Review of Adequacy of ESIA for the TEP Uganda Tilenga Oil Development Project

November 27, 2019

Bill Powers, P.E., E-Tech International

Figure 1a,¹⁴ exploratory drilling in 2011, & **Figure 1b,¹⁵ proposed permanent well pads**

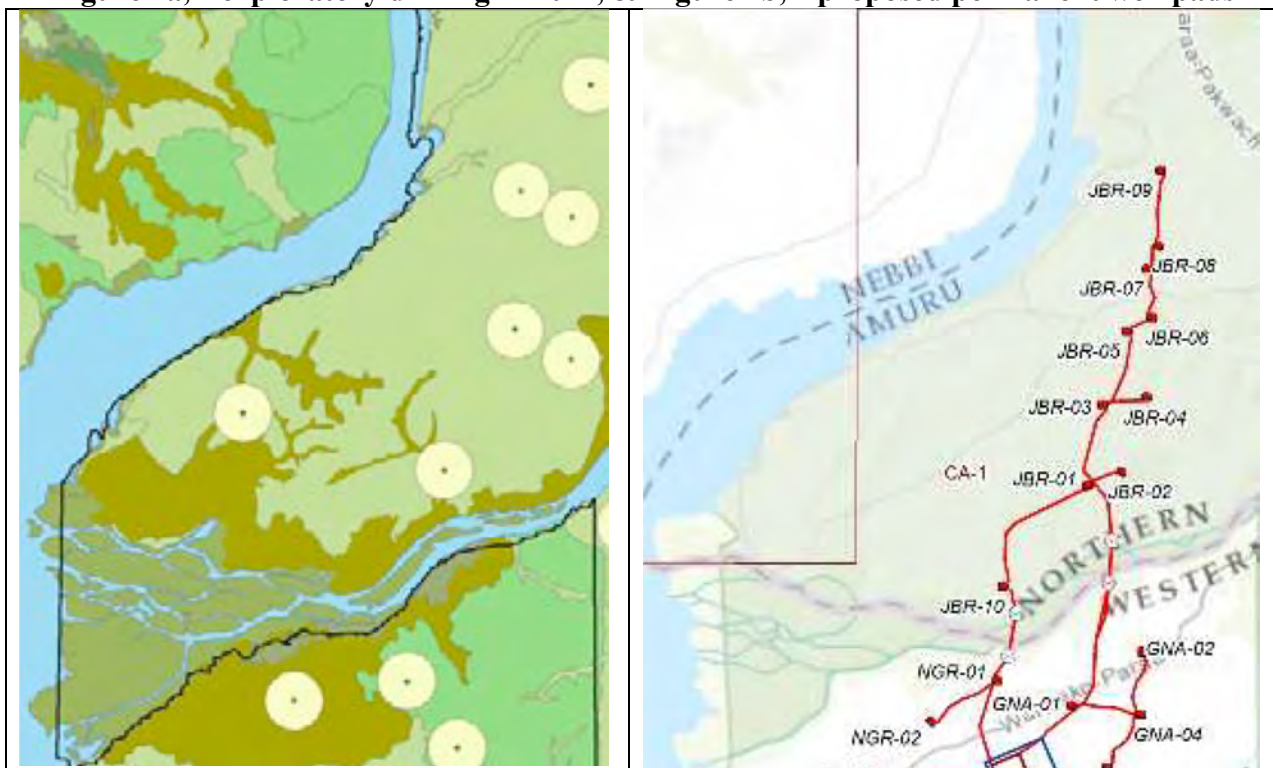
The close proximity of well pads in the exploratory drilling program in the Park will be replicated by TEP Uganda in the operational phase. As a result, the same impacts on wildlife documented in the 2011 study by Wildlife Conservation Society and Uganda Wildlife Authority are likely to recur in the operational phase. The locations of the exploratory well pads and the proposed permanent well pads are shown in Figures 1a and 1b.

The close spacing of the proposed production well pads in the Park will: 1) have a negative impact on elephant migration within the Park, 2) not maintain the status-quo of the ecosystem, and 3) not be in conformance with the SEA.

Figure 3. Alternative ERD well pad locations (two black dots) to access all drilling targets within Murchison Falls National Park with only one drilling pad inside the Park⁴⁰

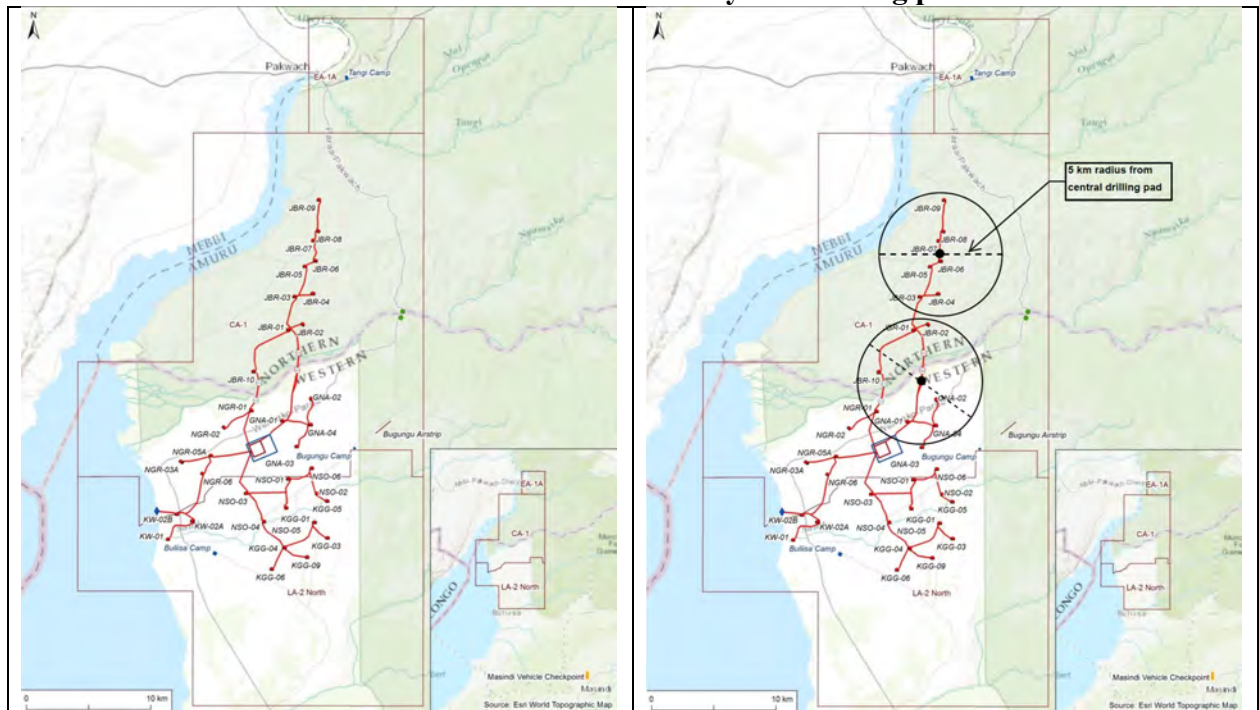
All target oil reservoirs in the Park can be reached by locating one ERD well pad in the Park near currently proposed well pad JBR-06, and a second well pad outside the Park boundary, about 2 km northwest of proposed well pad GNA-02 on the south side of the Victoria Nile. The TEP Uganda drilling plan described in the ESIA is the minimum cost, maximum surface impact approach, not the “best industry practice” approach that TEP Uganda states it will follow. The approximate locations of the two alternative well pad sites proposed by Powers Engineering, consolidating 13 proposed well pads into two ERD well pads, are shown in Figure 3.

Note: black dots and circles added by B. Powers represent potential ERD drill pad locations to access oil deposits within Murchison Falls National Park. Due to the shallow depths of the oil deposits, on average 500 m. or less, the maximum horizontal reach of ERD wells would be about 5,000 meters (5 km) based on the current state of ERD drilling technology.

Figure 4. Vertical depth and horizontal reach of ERD wells, worldwide, as of 2015⁴²

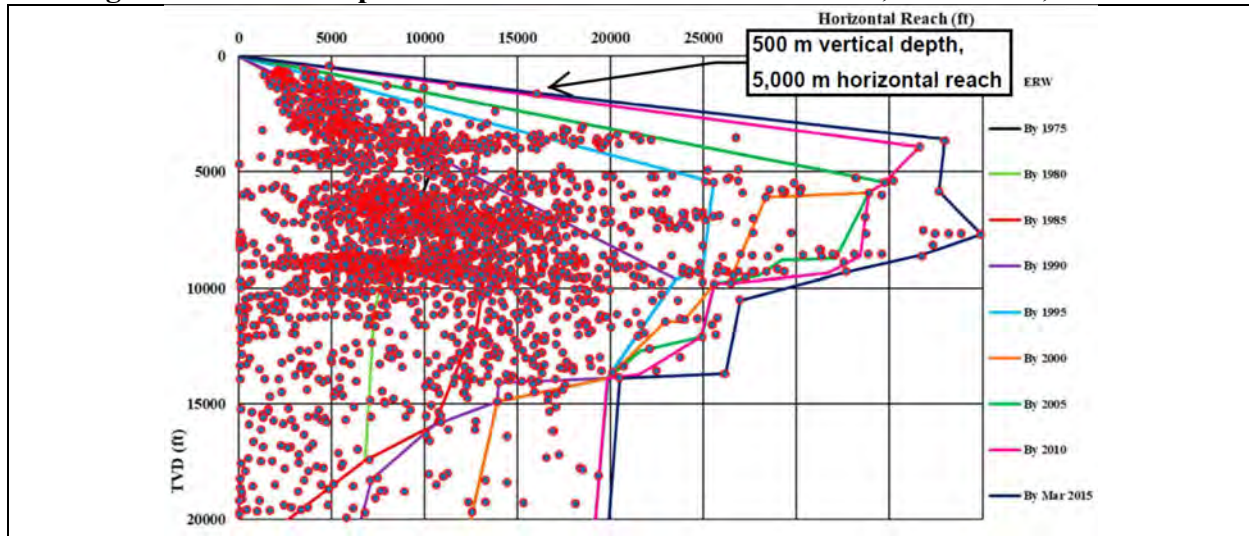
A graphical presentation of the horizontal length and the depth of existing ERD wells around the world is shown in Figure 4. Wells with target vertical depths of approximately 500 meters (1,600 feet) have been drilled 5,000 meters horizontally (16,000 feet) using ERD. The mean vertical depth of Tilenga Project wells in the Park will be approximately 400 meters.⁴¹ As a result, Powers Engineering assumes in this analysis that wells drilled using ERD can reach shallow reservoirs 5 km distant based on prior ERD drilling campaigns, as documented by the ERD wells in Figure 4, that have “demonstrated in practice” this capability.

Powers Engineering does not concur with TEP Uganda that “*the number of well pads has been optimised and reduced to as low as practicable including by use of directional drilling to concentrate more wells onto a well pad.*”⁴³ TEP Uganda proposes that the Tilenga wells extend up to about 2,000 meters horizontally from the well pad.⁴⁴ This horizontal distance is well short of the “demonstrated in practice” horizontal displacement for shallow ERD wells shown in Figure 4.

Figure 8. Schematic of horizontal directional drilling under a river⁸⁷

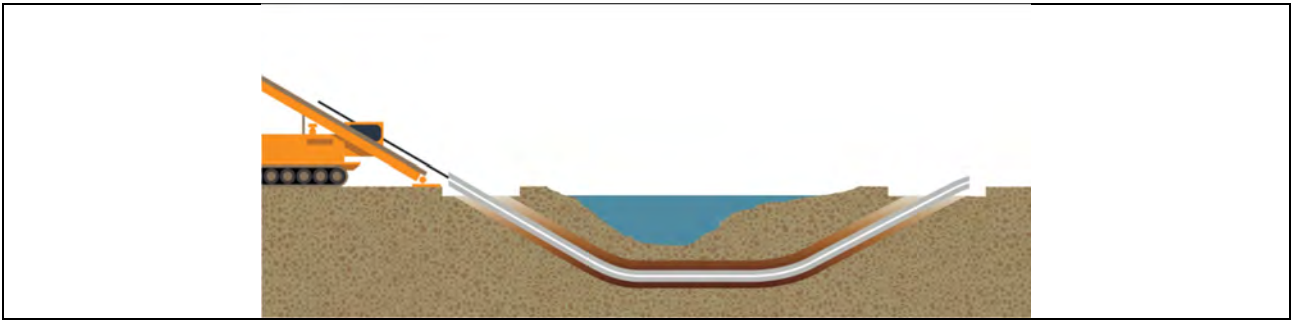
There are two primary options available to cross rivers and streams: 1) horizontal directional drilling (“HDD”) under the water body, and 2) open-cut trenching. The comparative cost of these two crossing alternatives is not discussed in the Tilenga ESIA. However, HDD is in routine use in the pipeline construction industry to cross waterbodies. The HDD technique involves drilling under the waterbody and avoiding any disruption to the waterbody itself. See Figure 8.

HDD will be used to cross the Victoria Nile.⁸⁹ Use of HDD is BAT for crossing a permanent river. However, in all other cases, “*the pipelines will be installed using open-cut trench methods.*”⁹⁰ The open-cut trench method is not BAT for permanent rivers or perennial streams. The ESIA states that there are several rivers within the (Tilenga Project) study area, as well as perennial streams, intermittent streams, ephemeral streams, and wetlands:⁹¹

Figure 10. Photographs of the open-cut buried pipe section that ruptured and the replacement pipeline bridge⁹⁷

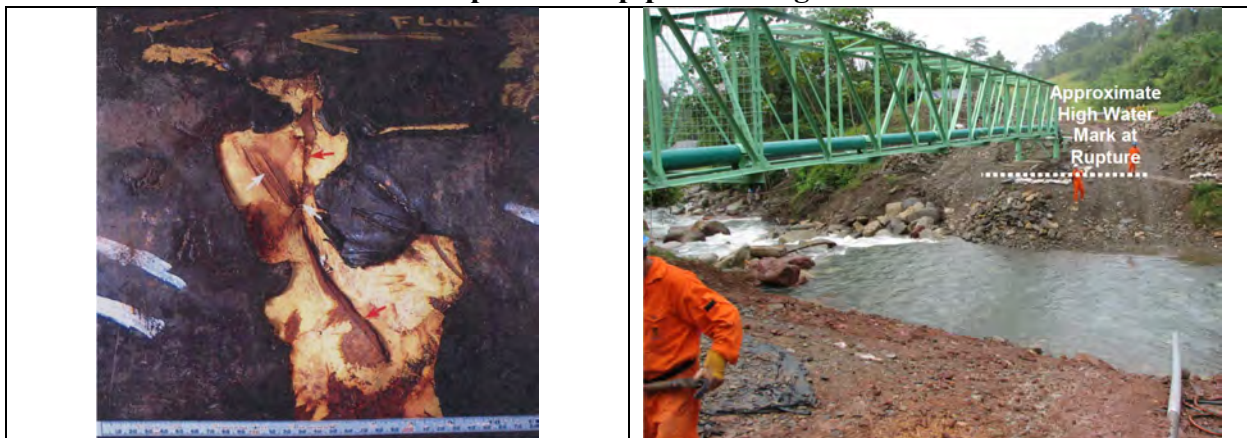
Open-cut trenching of pipelines in streambeds carries operational risks. A major rupture on the Camisea liquids pipeline in Peru occurred sixteen months after the pipeline began operation at a point where the pipeline had been placed under the streambed of the Paratori River using open-cut trenching.⁹² The river is less than 10 meters across where the rupture took place. The pipeline was exposed due to scouring of the streambed during a period of heavy rain.⁹³ It had been buried 2.1 meters below the stream bed.⁹⁴

The automatic leak detection system did not register that a leak had occurred. The pressure reduction caused by the rupture “*was not sufficiently large to activate the automatic rupture detection mechanism of the block valves upstream and downstream of the rupture.*”⁹⁵ The rupture was detected when control room operations staff identified a reduction in flow at the downstream pump station. The nearest block valves were ultimately closed about one hour after the rupture occurred. Approximately 4,600 barrels of liquid hydrocarbons were spilled into the stream.⁹⁶ Figure 10 shows the damaged pipe section and the pipeline bridge that replaced the pipeline section that had been buried under the streambed.
